SUBJECT: NRR SALP III ASSESSMENT FOR MIDLAND PLANT, UNITS 1 & 2

FACILITY NAME: Midland Nuclear Plant, Units 1 and 2

APPLICANT: Consumers Power Company  
FACILITY: Midland Plant, Units 1 and 2  
SUBJECT: SUMMARY OF AUGUST 25, 1980 MEETING ON LICENSING STATUS OF THE  
MIDLAND PLANT, UNITS 1 AND 2

SUBJECT: CORP OF ENGINEERS REPORT AND REQUEST FOR ADDITIONAL INFORMATION ON PLANT FILL

TABLE 35-1

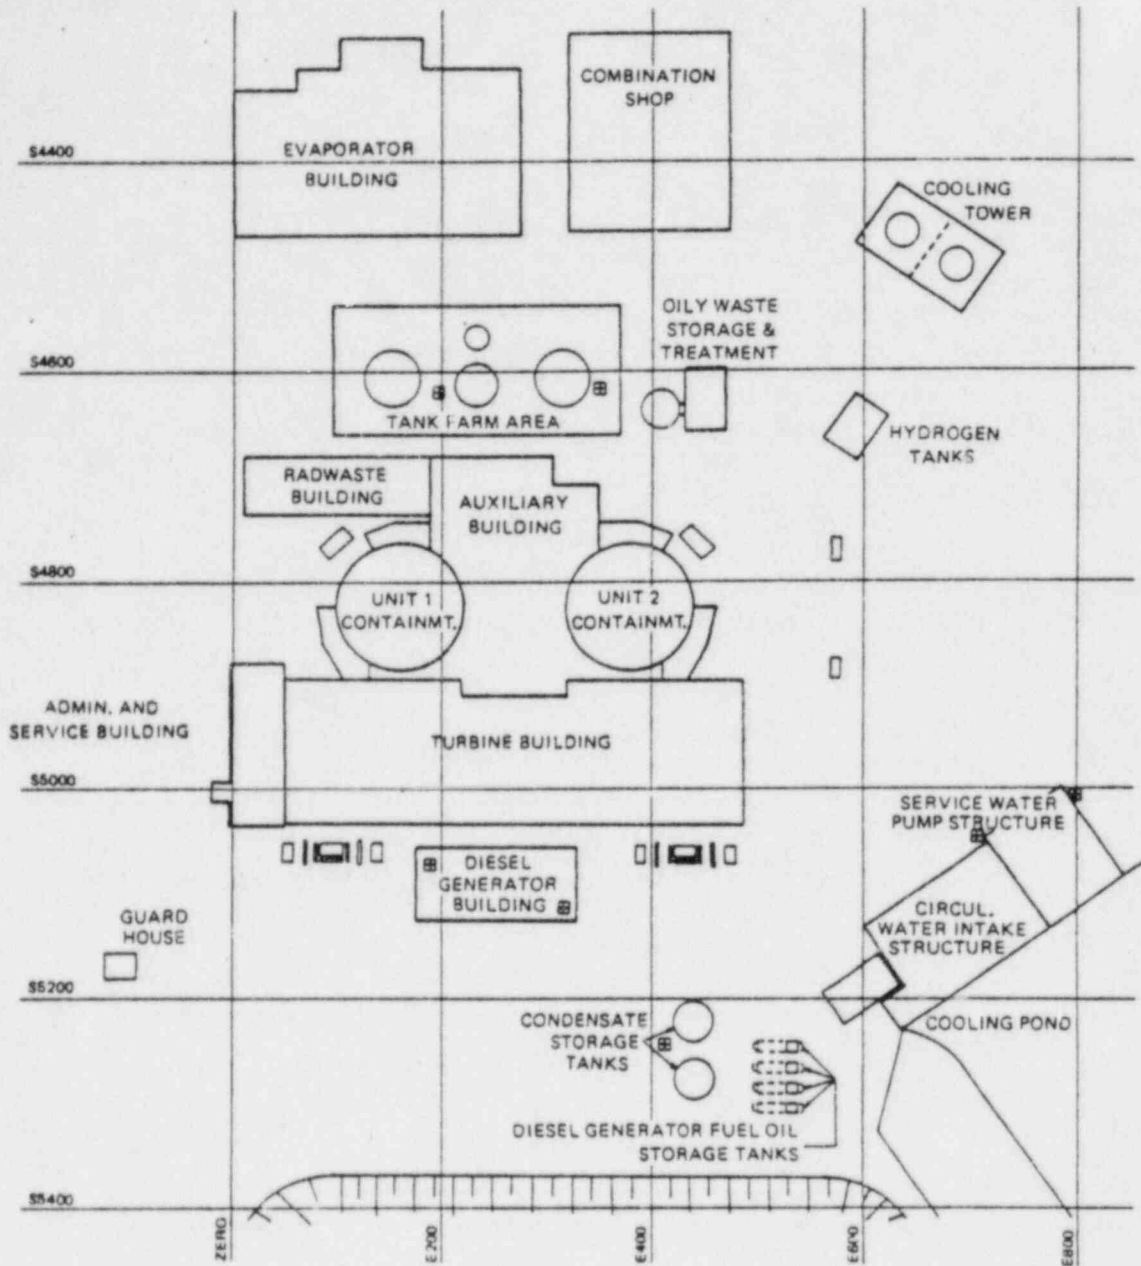
(2) Bearing Capacity. Applicant's response to NRC Question 35 (10 CFR 50.54f) relative to bearing capacity of soil is not satisfactory. Figure 35-3, which has been the basis of selection of shear strength for computing bearing capacity does not reflect the characteristics of the soils under the Diesel Generator Building. A bearing capacity computation should be submitted based on the test results of samples from new borings which we have requested in a separate memo. This information should include method used, foundation design assumptions, adopted soil properties and basis for selection, ultimate bearing capacity and resulting factor of safety.

The dynamic response of a structure is evaluated using analytical procedures normally requiring an estimate of the dynamic shear modulus of the supporting medium. The shear modulus can be calculated from in-situ shear wave velocity tests using the cross-hole procedure. Rebound measurements obtained during preload removal will also provide additional evaluation of the dynamic stiffness values. This is possible because of the short duration involved in preload removal and the limited strain associated with unloading. Both of these procedures were implemented for the diesel generator building. The rebound data showed the building short-term rebound was in the range of 0.16 to 0.24 inch. These data were used to calculate the values of Young's modulus, shear modulus, and the corresponding shear wave velocity as given in Table 35-1. Cross-hole shear wave velocity measurements were also made at the diesel generator building and other locations in the plant area fill as shown in Figure 35-1. Figure 35-2 is a combined plot showing results of the shear wave velocity measurements conducted at different locations in the plant area fill along with the estimated shear wave velocity values based on the diesel generator building rebound measurements. This figure also shows that the shear wave velocity data based on cross-hole tests are generally higher than those calculated based on rebound, as might be expected, because a portion of the building rebound is attributed to rebound of the natural soil below the fill. Such a rebound below the fill would result in an increase in the calculated moduli and velocities for the fill.

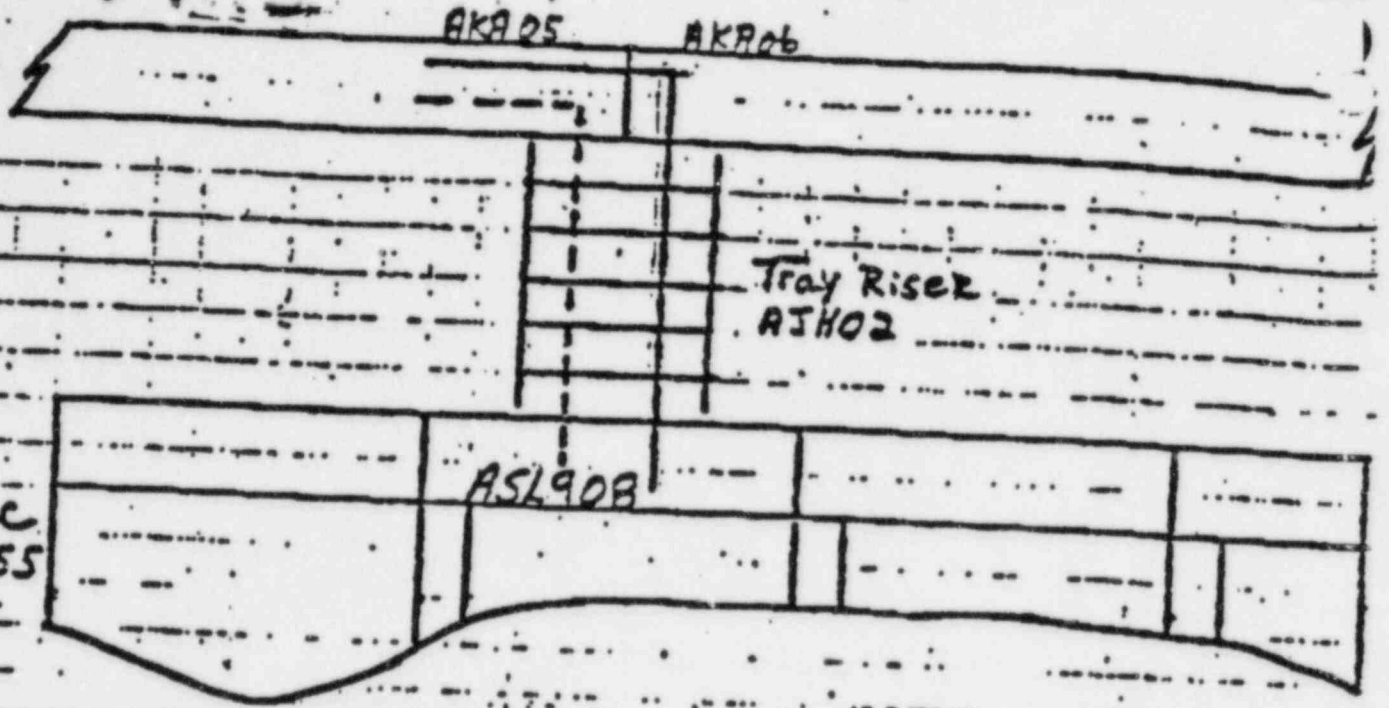
The subject cable enters the confines of an additional raceway. If the trays containing subject cable were required to be wrapped, how do we make sure that the cable is protected.

When a cable enters the confines of additional vias, the tray wrapping criteria would require wrapping to the edge of the violation and approximately 12 more inches at each end for safety.

SK 8

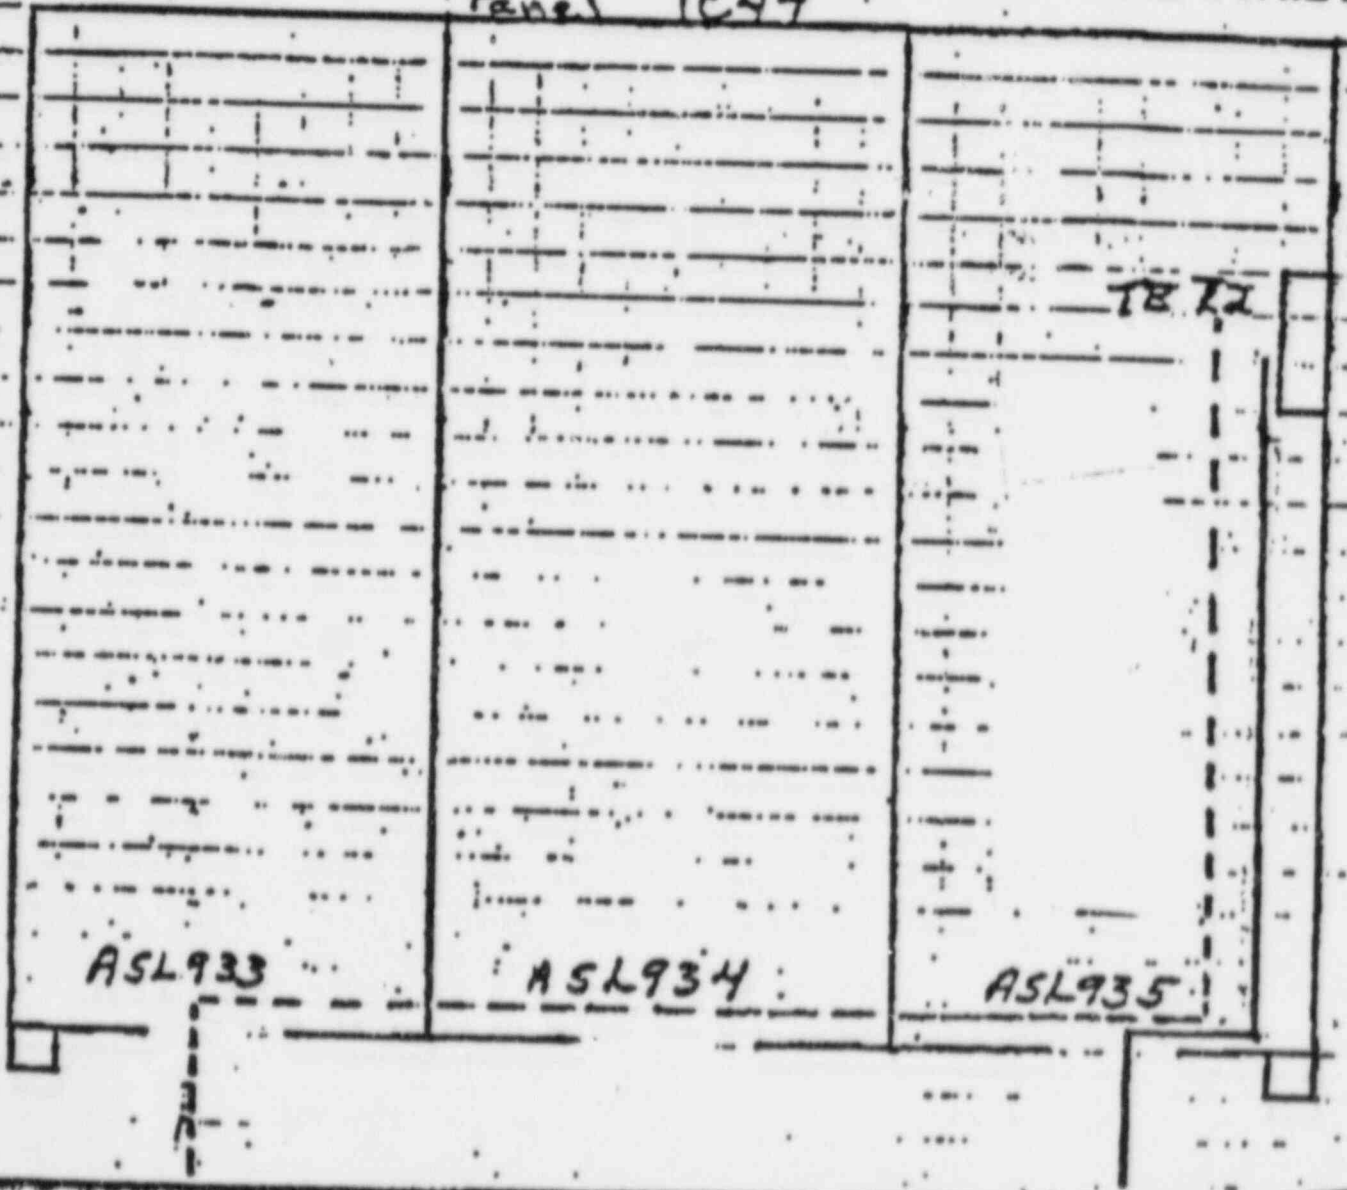
Cable was routed to the wrong compartment of the control panel. Field discovered E37 error then pulled and terminated cable at the correct compartment. E37 did not reflect as-built condition.

When construction attempts to terminate a cable and discovers that the cable is in the wrong compartment, field engineering is notified of the problem.

SK-9

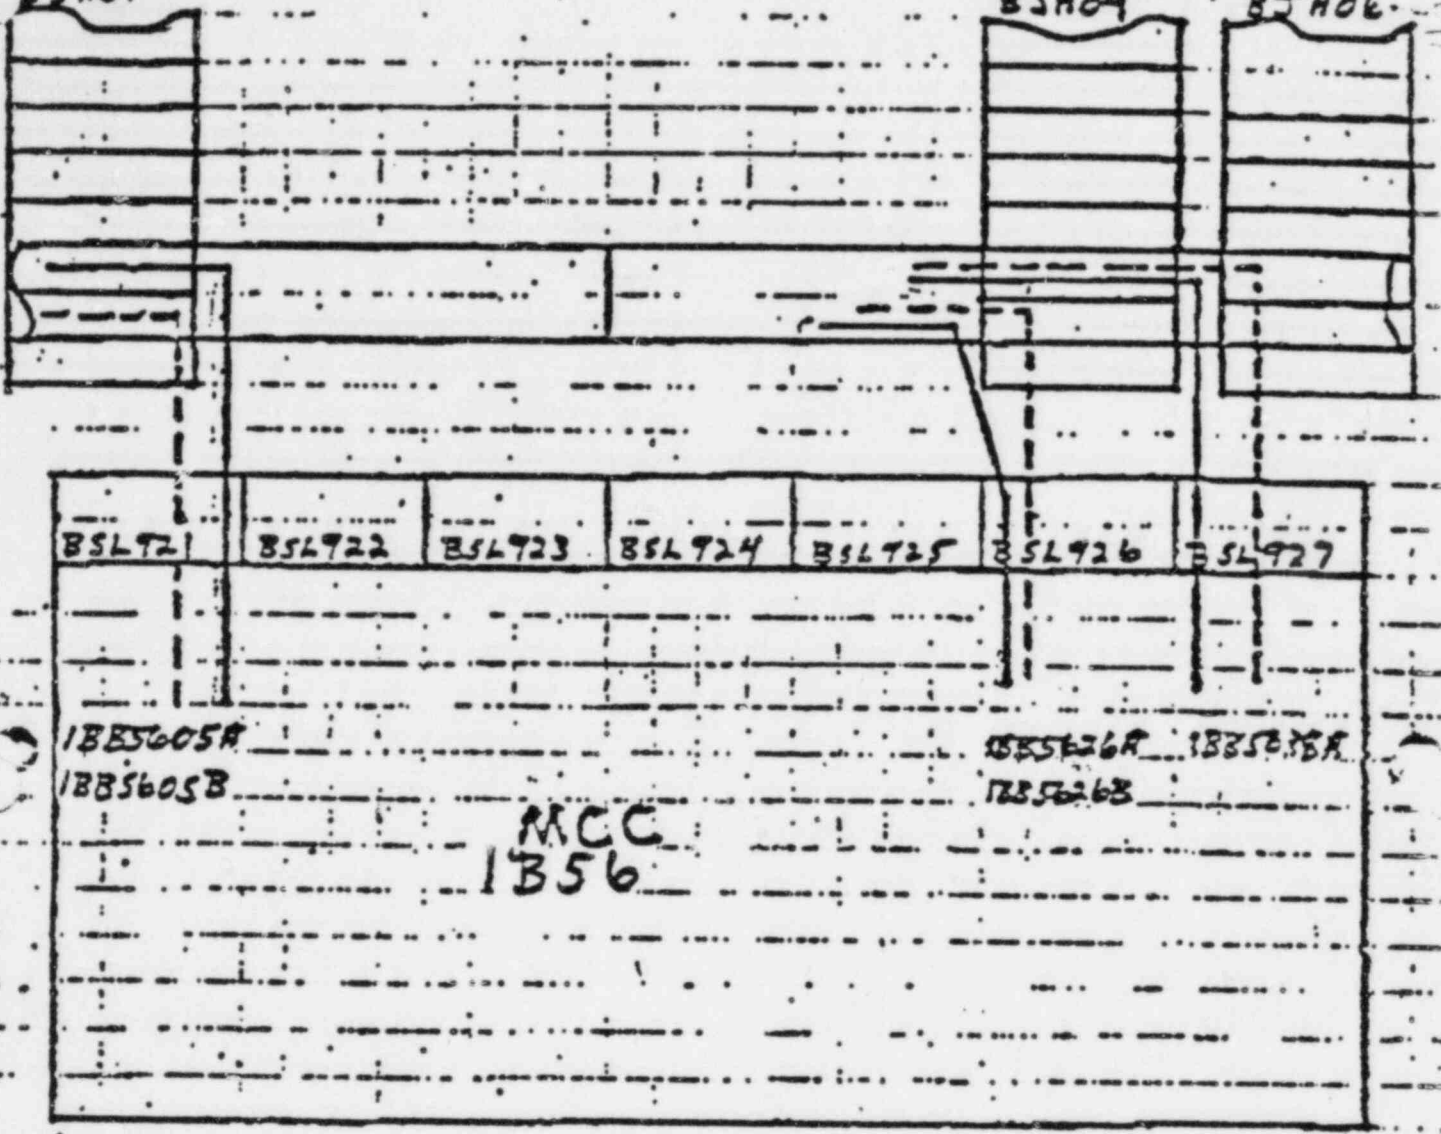
Accountability; i.e., not knowing where a cable is pulled.

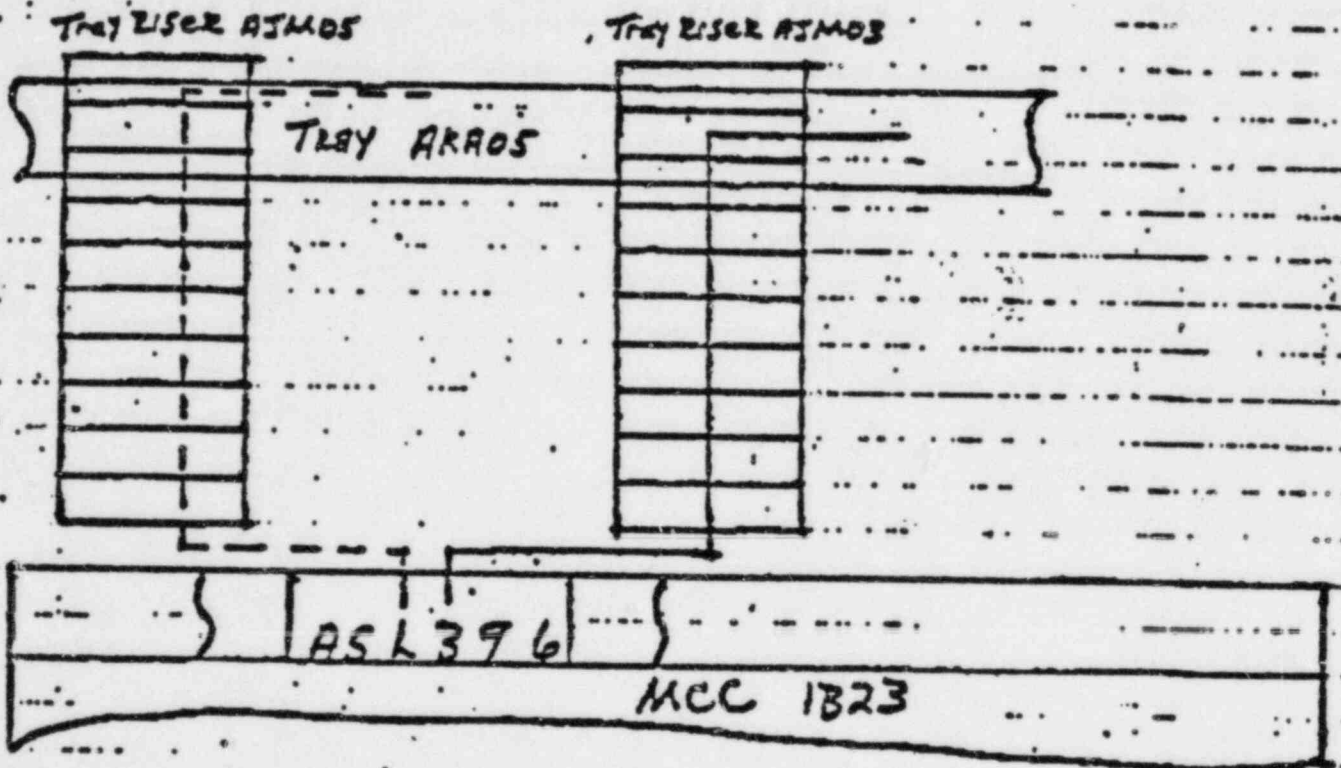
Cables are airlined, and are not in the riser.

A cable can be airlined 3 feet without engineering approval.

SK-14

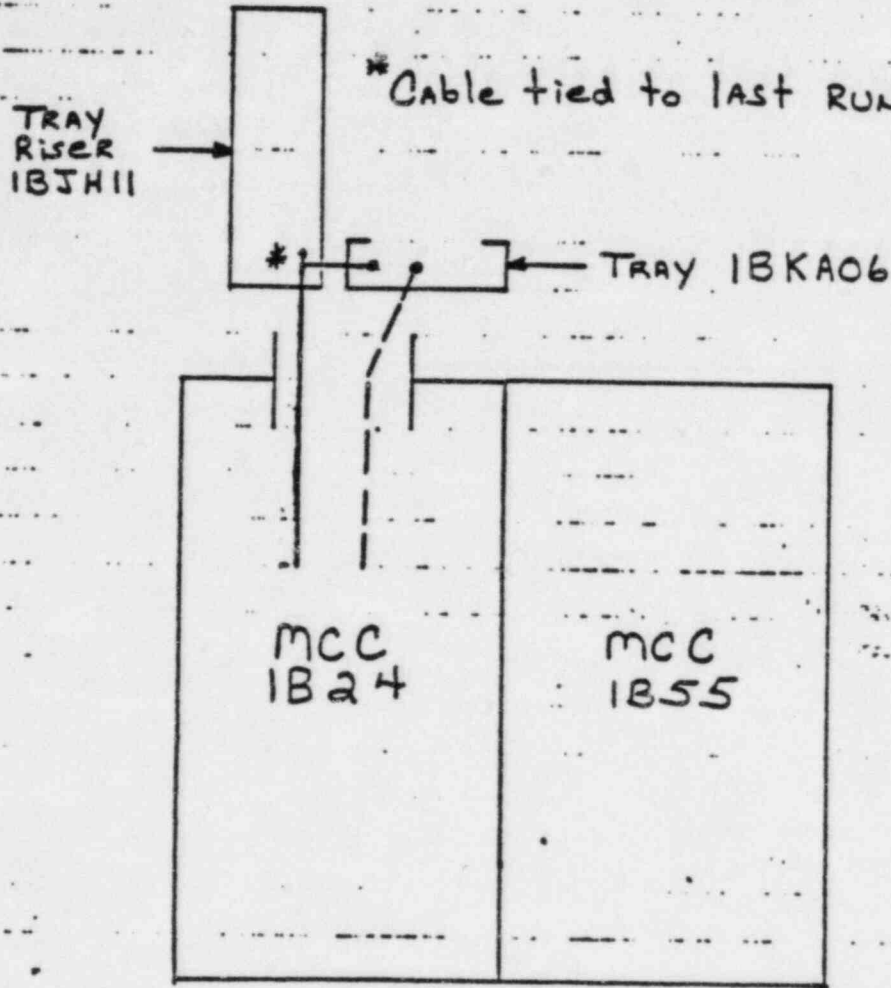
The subject cable enters the confines of additional raceway. If the trays containing the subject cable were required to be wrapped, how do we make sure that the cable portion in the unlisted via is protected.

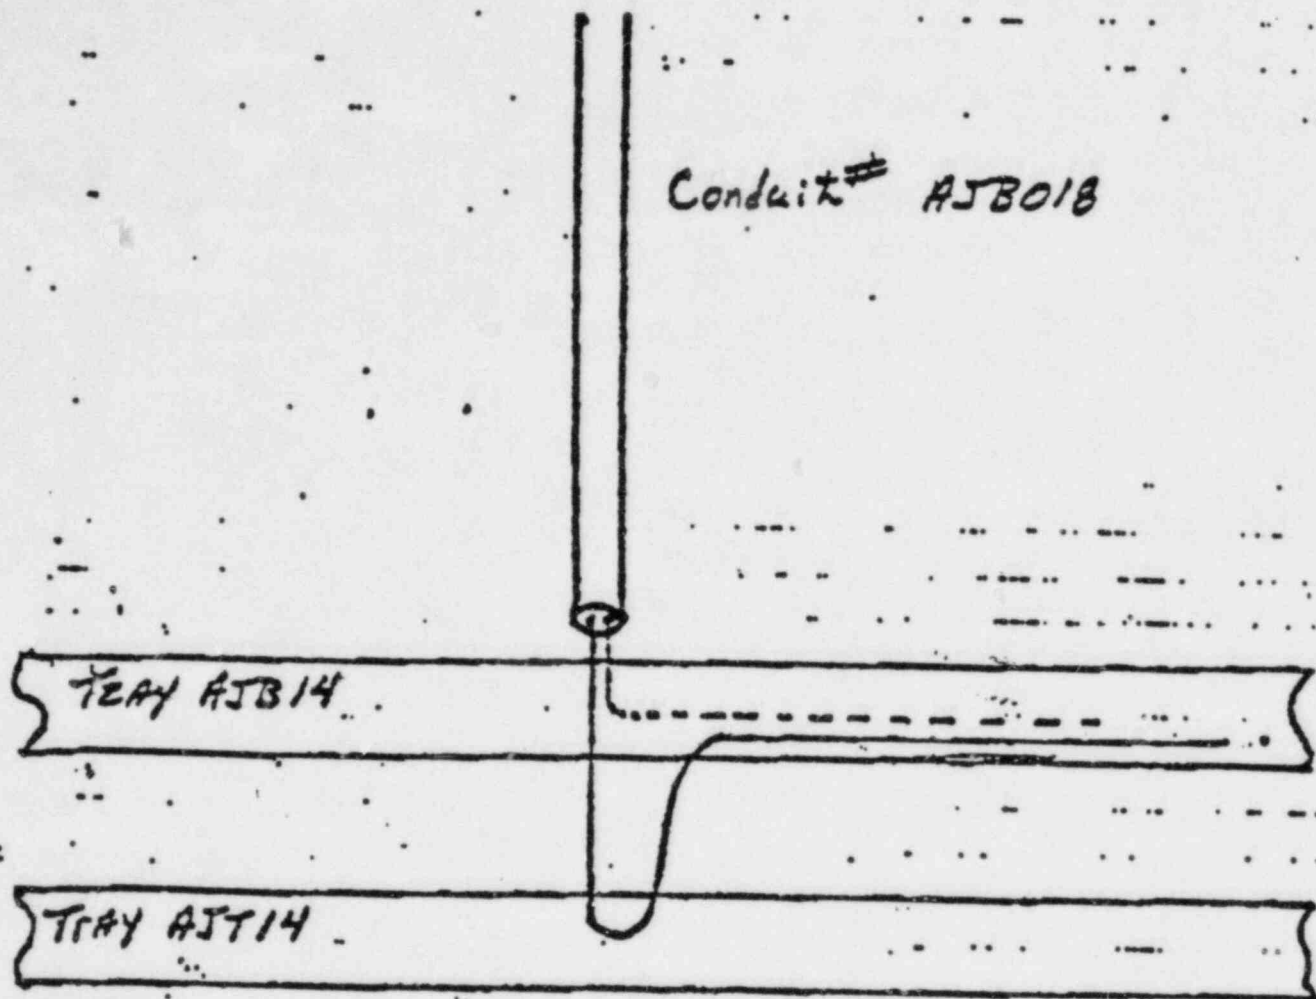
Cable is pulled into BJH11 which was not one of its assigned  
vias.

The cable is only tied to the last rung of the riser, and will  
not contribute to thermal loading of the riser.

SK 20  
Midland Plant Units 1 and 2  
Attachment 3 to  
Report on Cable Installation

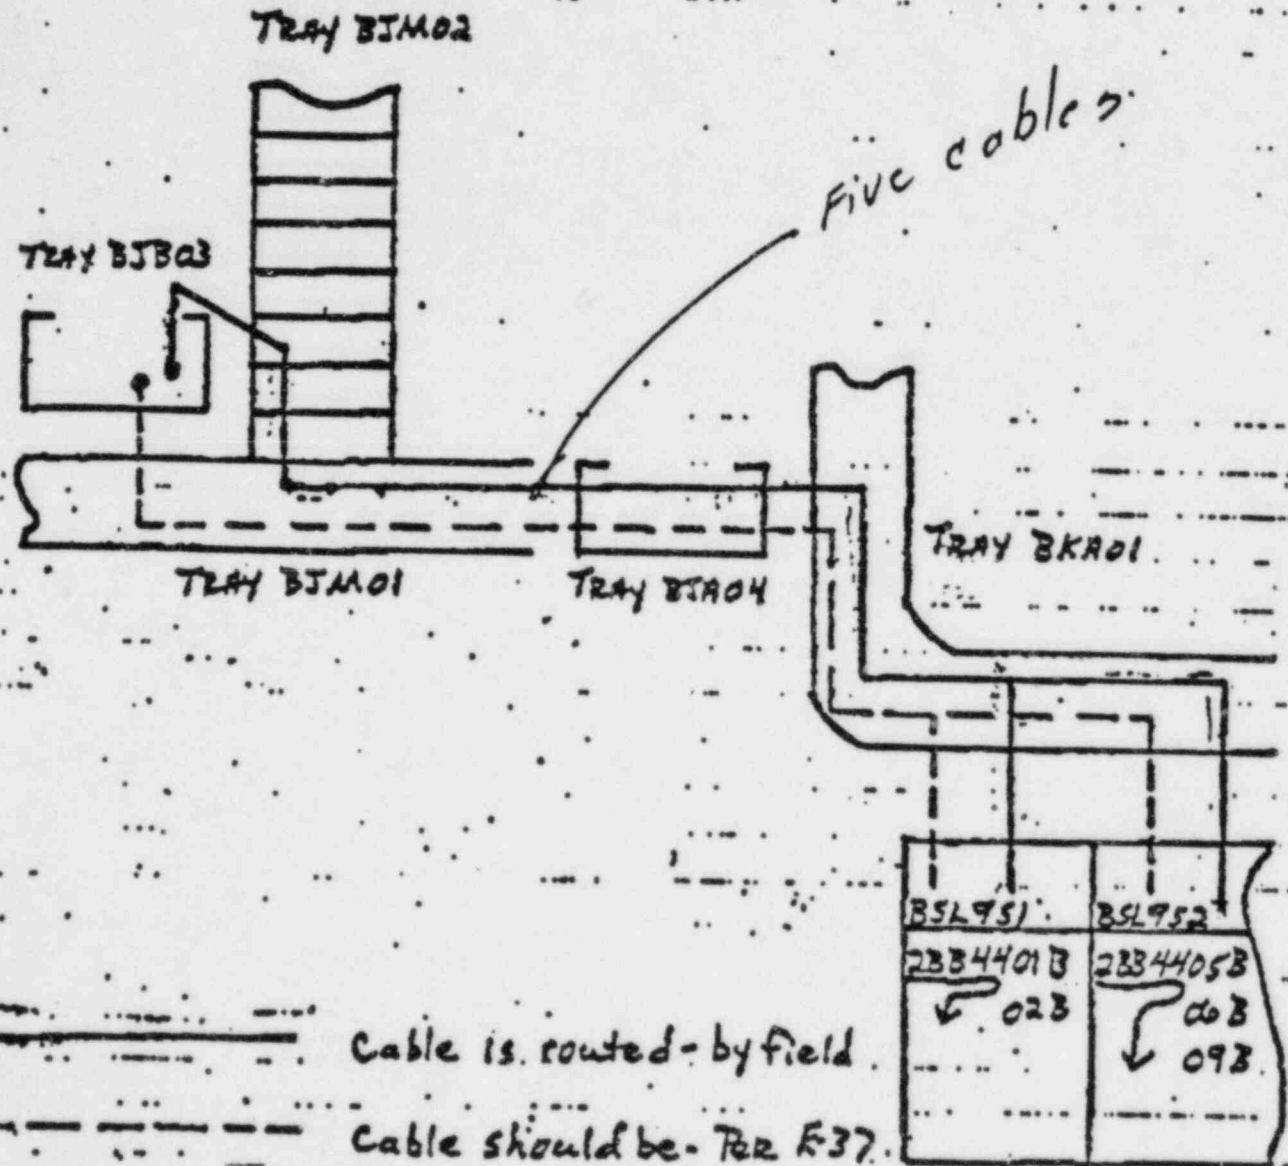
Accountability; i.e., not knowing where a cable is pulled. This problem may have an adverse affect on thermal analysis.

When a tray is wrapped, heat generated from cables in the tray must be taken into consideration. If a cable were pulled into that tray and engineering was not aware of it, the thermal analysis would not include that cable.
